## **Annexure 2**

Urban Design Advisor Assessment

In the matter of The Resource Management Act 1991  
and  
In the matter of Land use resource consent under the Wellington City Council Operative District Plan for the construction of two new buildings at 1 Molesworth Street in the Parliamentary Precinct.  
By Simpson Grierson on behalf of Parliamentary Services

**STATEMENT OF EVIDENCE OF  
SARAH DUFFELL (URBAN DESIGN)  
ON BEHALF OF WELLINGTON CITY COUNCIL  
20 January 2023**

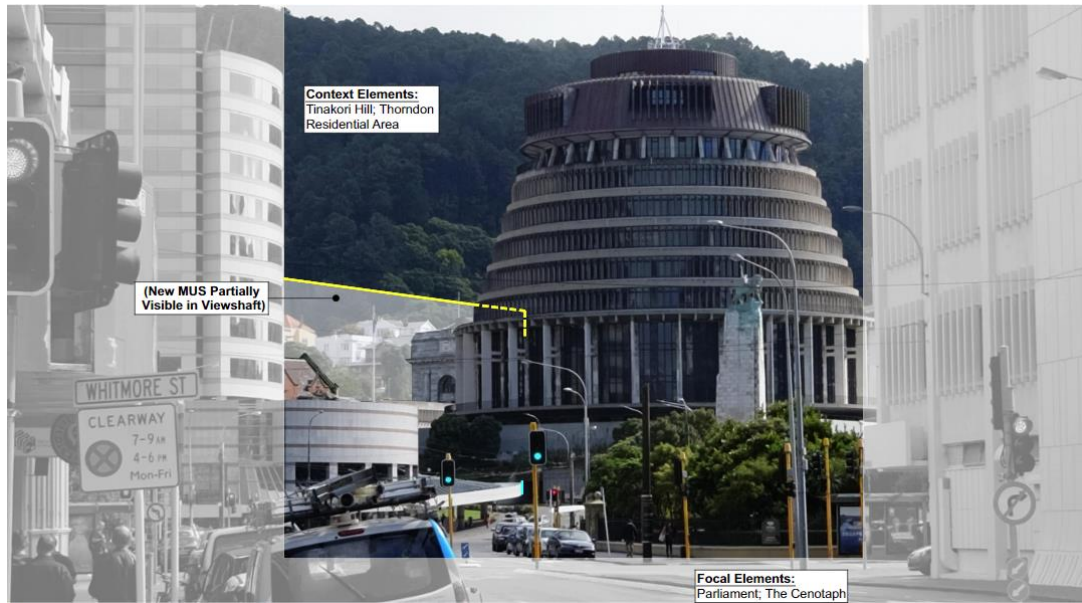
As stated, there will be no alteration to the front/eastern side of the site. Additionally, construction of the Ballantrae Building will remove any security risk of inbound goods and services to a discrete location on the site. This is beneficial for the security and ongoing protection of the both the existing Beehive Building and the wider site.

**G1.9** *Consider the possibility of uncovering archaeological material when any earthworks or subsurface investigation are planned.*

The applicant has applied for, and had granted, an Archaeological Authority by Heritage New Zealand/Pouhere Taonga.
